**6F50/6F55 TRANSMISSION—SLUGGISH
ACCELERATION FROM 0-8 KM/H (0-5 MPH)
FOLLOWED BY A HARSH BUMP OR A SLIP ON
TAKE-OFF FOLLOWED BY A BUMP—BUILT ON OR
BEFORE 4/15/2011**

TSB 11-12-10

This article supersedes TSB **11-9-11** to update the Service Procedure.

Figure 1 - Article 11-12-10

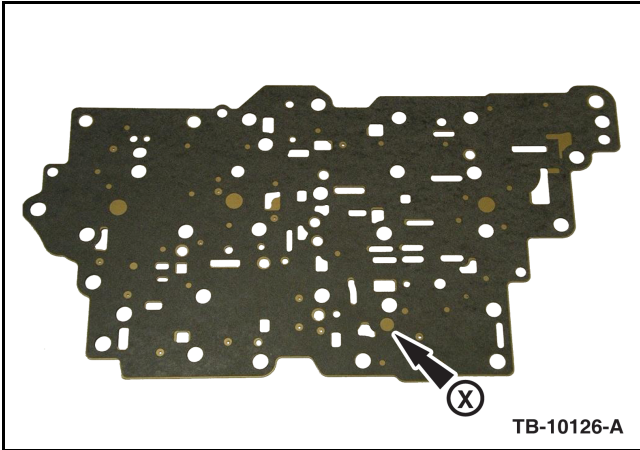
There is a new calibration and transmission valve body change to correct this condition. The valve body change was to delete one hole in the valve body separator plate and remove one check ball from the valve body in the same area where the hole in the separator plate was deleted.

1. For all model years except 2009, proceed to Step 2. For 2009 model year vehicles, verify the transmission dipstick has MERCON® LV listed on the dipstick.
 - a. Yes - The dipstick has MERCON® LV listed on the dipstick; proceed to Step 2.
 - b. No - The dipstick does not have MERCON® LV listed on the dipstick; this procedure does not apply. Follow normal Workshop Manual diagnostics.
2. Reprogram the PCM to the latest calibration using IDS release 73.04 and higher. This new calibration is not included in the VCM 2011.5 DVD. Calibration files may also be obtained at www.motorcraft.com.
3. Remove the transmission valve body. Refer to the Workshop Manual (WSM), Section 307-01.
4. Replace both separator plates listed in the Parts List. The X identifies the hole in the valve body separator plate which will be eliminated. (Figure 1)

Figure 2 - Article 11-12-10

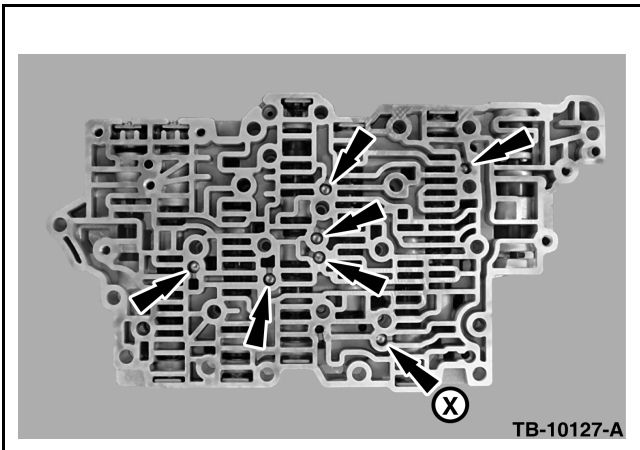
5. Remove one (1) check ball identified as X. (Figure 2)

- a. Proper check ball locations on the remaining six (6) valve body check balls shown with arrows. (Figure 2)
6. Install transmission valve body. Refer to WSM, Section 307-01.
